STATE OF FLORIDA DEPARTMENT OF TRANSPORTATION

2010 Interim Design Standard

12" SQUARE PRESTRESSED CONCRETE PILE

Index No. 20612

ALTERNATE STRAND PATTERNS

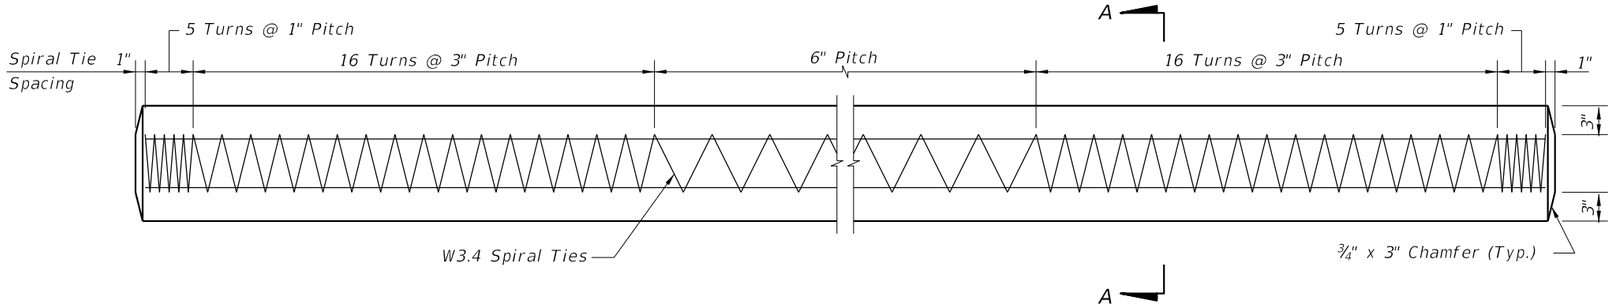
DATE	BY	DESCRIPTION	DATE	BY	DESCRIPTION
07/01/10	GJM	"ALTERNATE STRAND PATTERNS" Added: "8 ~ ½" Ø (Spec), Grade 270 LRS, at 25 kips", "8 ~ ½" Ø, Grade 270 LRS, at 24 kips"; Changed: 8 ~ 7/16" Ø, Grade 270 LRS, to "23 kips"; 12 ~ 3/8" Ø, Grade 270 LRS, to "16 kips". Deleted: "SR" strand pattern options.

4 ~ 0.6" Ø, Grade 270 LRS, at 44 kips
8 ~ ½" Ø (Spec), Grade 270 LRS, at 25 kips
8 ~ ½" Ø, Grade 270 LRS, at 24 kips
8 ~ 7/16" Ø, Grade 270 LRS, at 23 kips
12 ~ 3/8" Ø, Grade 270 LRS, at 16 kips
